Our Ref: P-17171

**RE: RESPONSE TO QUERIES IN RELATION TO S75W MODIFICATION OF CONCEPT APPROVAL
FOR MAJORS BAY MP 10_0154 (MOD 3)**

We refer to the Section 75W Modification application (MP 10_0154 (MOD 3)) that is currently being assessed by the Department of Planning and Environment (DoPE), and the DoPE's email dated 21 February 2019.

Figure 1: Existing Parking Arrangement in the location of the proposed Gymnasium on Lower Ground Level (left) and the indicative location of the proposed parking (right) (Source: Turner/Holdmark)

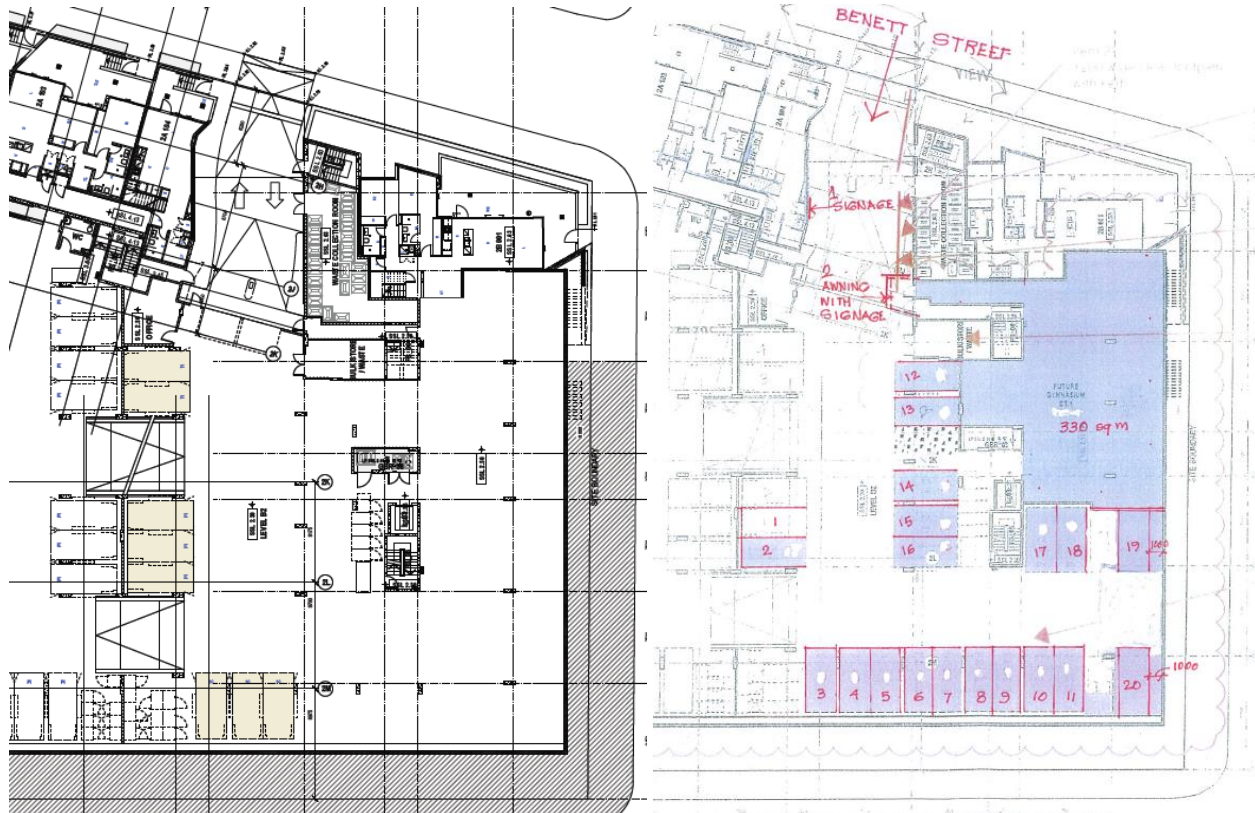
The previous use of the spaces associated with the car parking for the proposed gym and hospital. I understand from your application that 7 spaces were surplus parking spaces from the required spaces for the apartment building DA, however there are an additional 14 spaces which have been accommodated within the basement envelope. Please provide a copy of the latest approved stamped plans for the residential building.

As such, the proposed gymnasium will need to reduce in size so that the existing building can accommodate the required parking spaces for the future DA. On this basis the proposed gymnasium is sought to be reduced to 330m² (from 373m² originally proposed). This proposal will attract an overall parking rate of 19 car parking spaces (15 spaces for the gymnasium and 4 spaces for the medical centre). Thus, an additional fourteen (14) car parking spaces are required within the building to accommodate the proposed gymnasium

and medical centre uses. These additional car parking spaces can be accommodated in the general location of the proposed gymnasium on the lower ground level, as demonstrated below in **Figure 1** which shows a total of fifteen (15) additional spaces surrounding the gymnasium.

PART G.F
PLAN OF GYM.

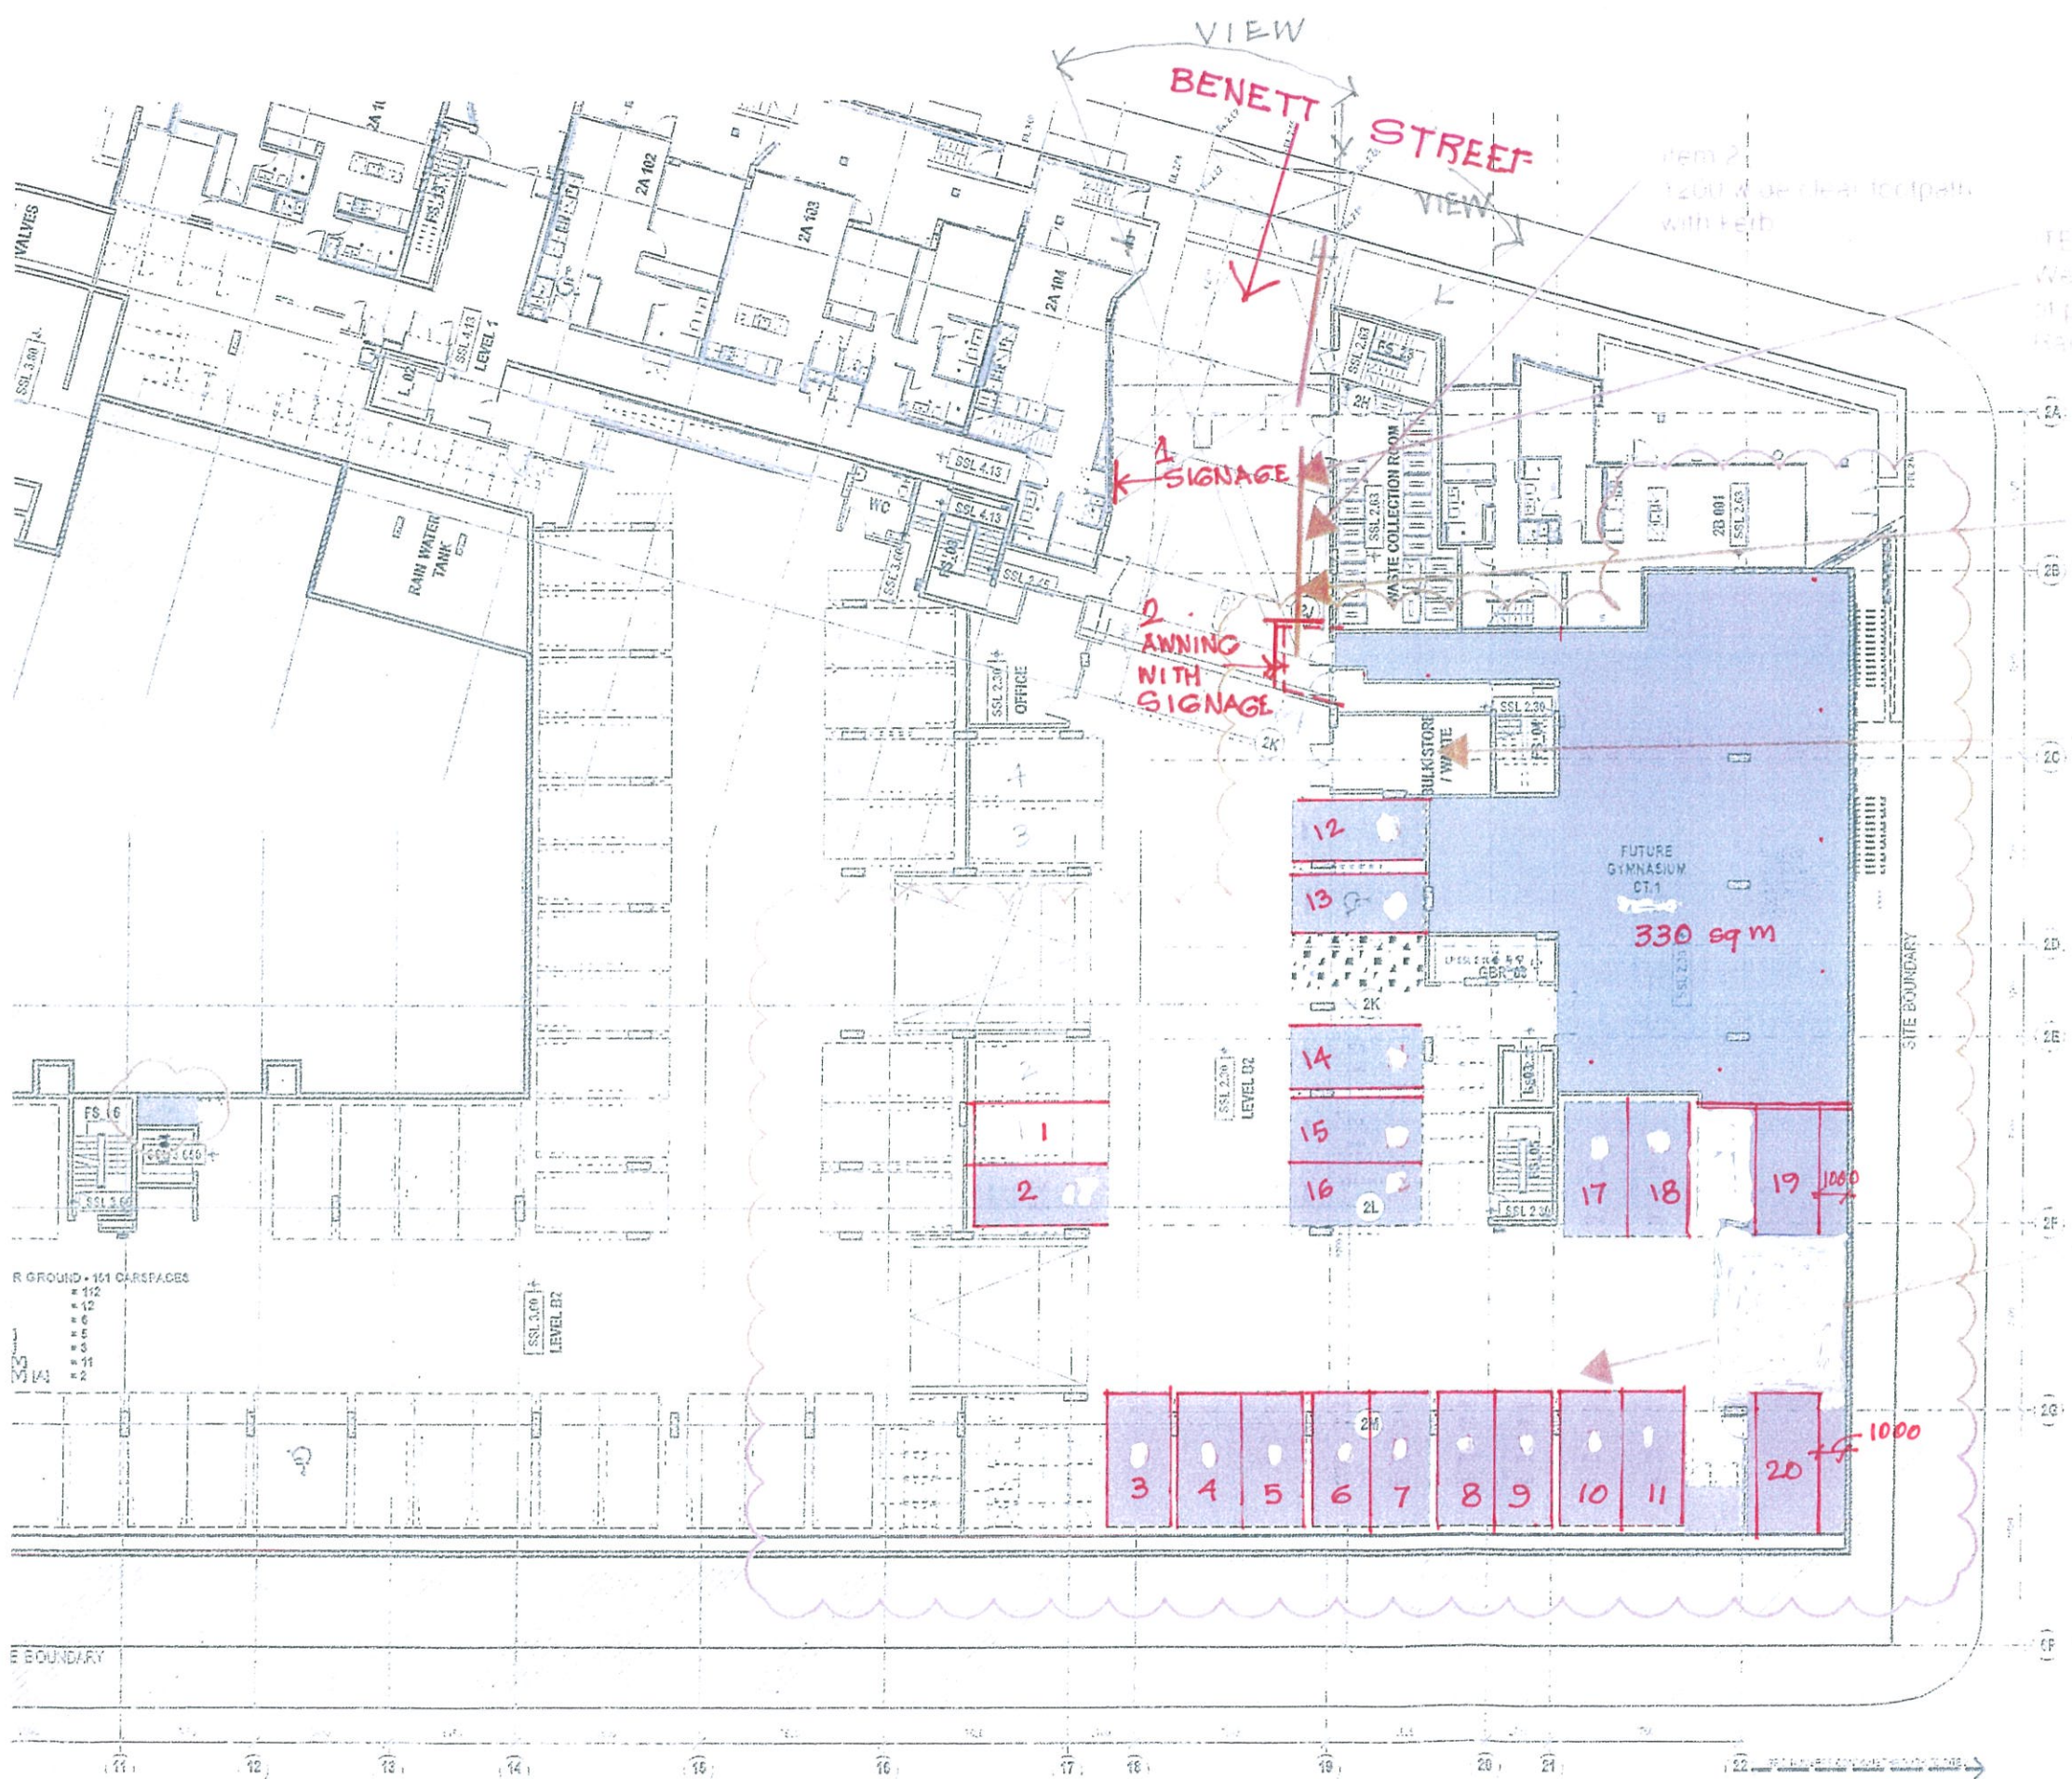
The possible location of signage required for the uses.

Consideration and assessment of any privacy impacts to the residential uses associated with the modification, particularly when pedestrians access the uses.Medical Centre

Please refer to **Annexure 3**, which indicates possible locations of signage for the proposed uses. As per our letter dated 18 December 2018, signage for the gymnasium can be placed on the driveway walls and on a small awning that will be located over the doorway, so that it is visible from the public domain. Signage for the medical centre can be located on a small awning above the doorway of the premise and/or on the side of the building and will be visible from the public domain and Hilly Street. Please refer to **Annexure 3** which has indicatively shown the location of signage. Any future DA will seek consent for signage, and the appropriateness of the signage in terms of its details/location/scale/materials will be assessed at this stage.

The predominant access to the medical centre will be via common stairs between the building connecting to Bennett Street and Hilly Street. These stairs are currently accessible by the general public and the residents of the building. The proposed addition of the medical centre will not have any adverse amenity impacts to the existing residential units within the development, particularly given the size of the medical centre. The most sensitive residential unit from the medical centre is the unit that is adjacent the medical centre entry on Level 0. To minimise additional privacy impacts, the proposed entry to the medical centre could be located further away from the adjacent window, as well as the introduction of privacy screens to the units windows as indicatively shown on the sketch plans prepared at **Annexure 3**
